SUBJECT: OCTOBER 2003 MONTHLY OPEN ITEM STATUS REPORT

NRC Monthly Open Item Status Report: Mixed Oxide Fuel Fabrication Facility Construction Authorization Request

NRC Monthly Open Item Status Report: MFFF Construction Authorization Request

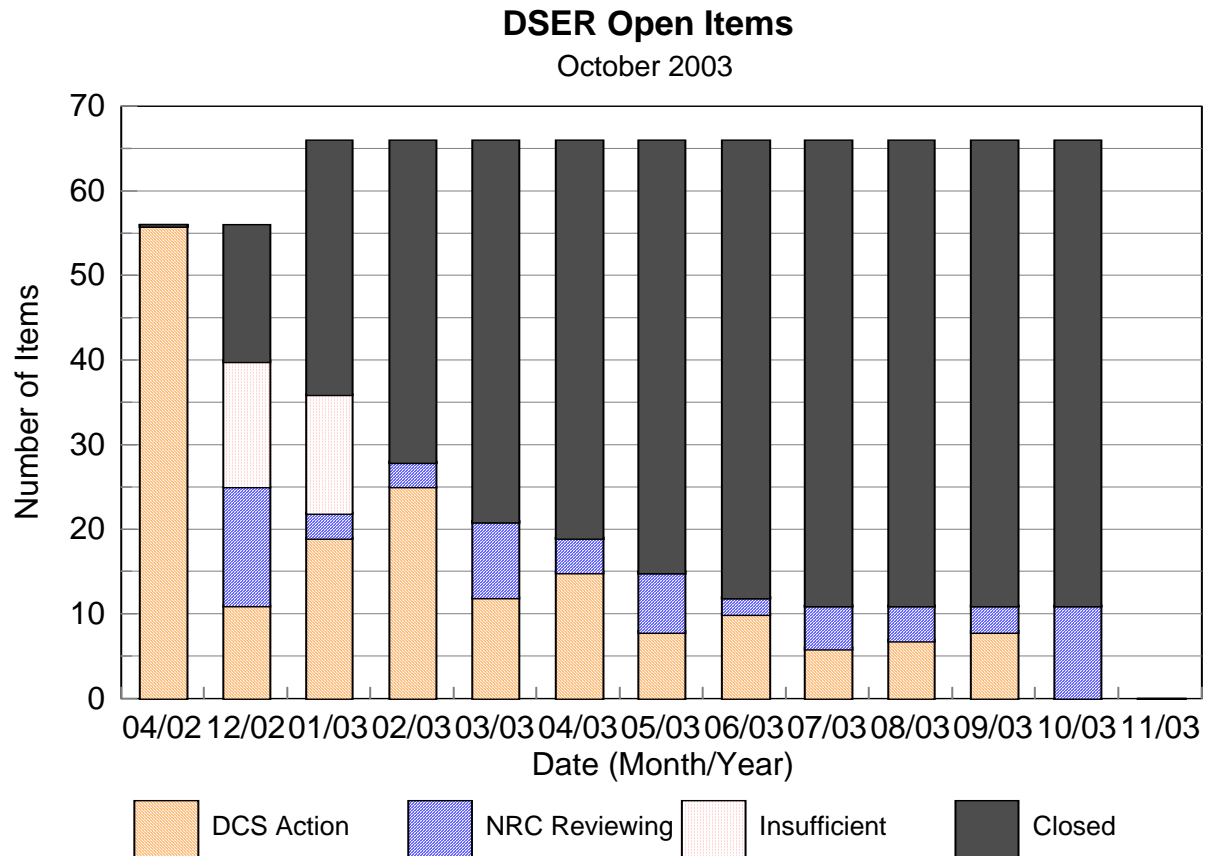
The attached table provides the status of the staff's review of open items. The table contains the 19 open items identified in Appendix A of the April 30, 2003, Draft Safety Evaluation Report (DSER). The figure showing the closure of open items since April 2002 has been retained and shows the disposition of the original 66 open items.
